Submitted by the expert from Australia

DRAFT PROPOSAL FOR A GLOBAL TECHNICAL REGULATION ON POLE SIDE IMPACT

IMPACT REFERENCE LINE

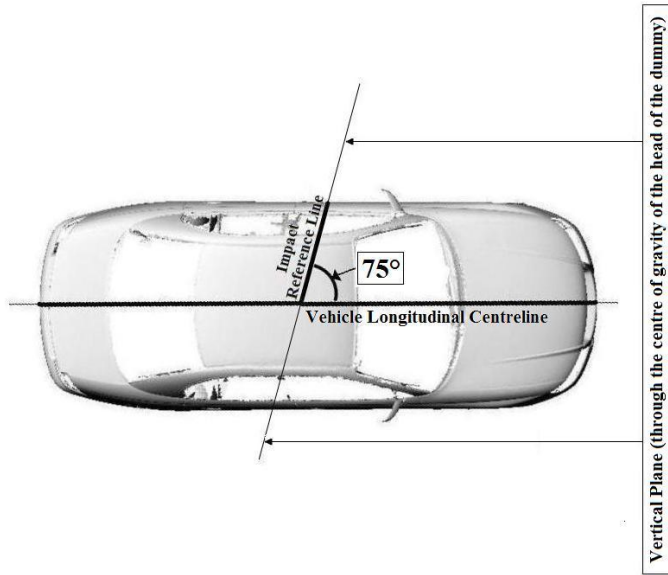
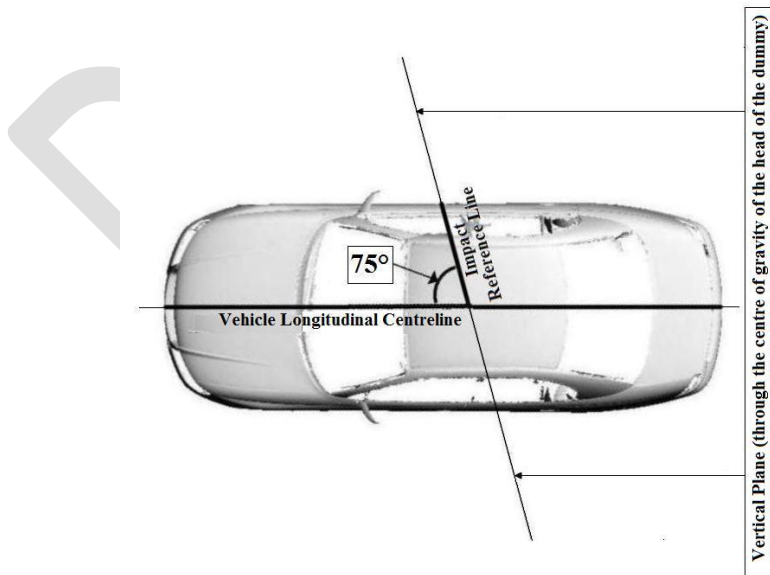
Comment [tb224]: Inserted to enable simplification of impact reference line definition and improve clarity.

IMPACT ANGLE

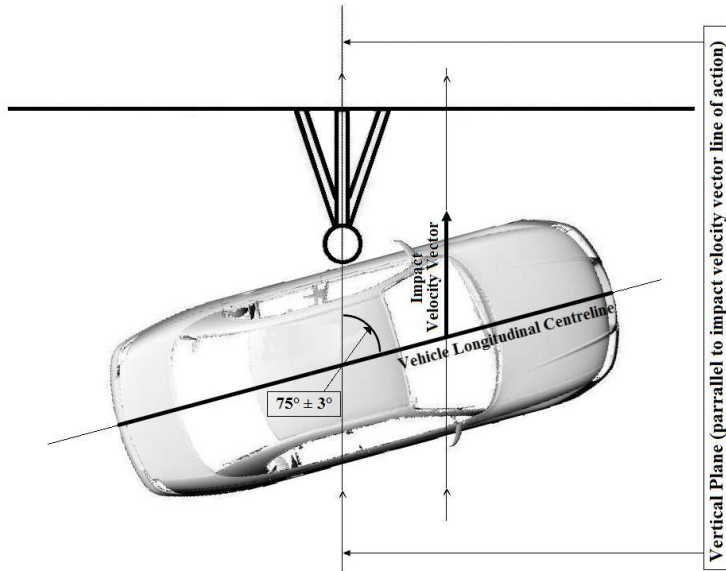
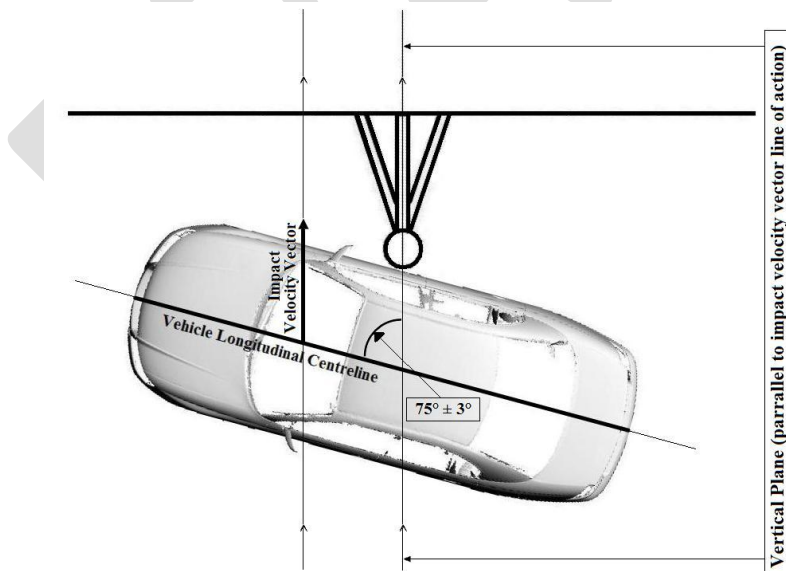
Comment [tb225]: Inserted to allow simplification of angle of impact related clauses and improve clarity.
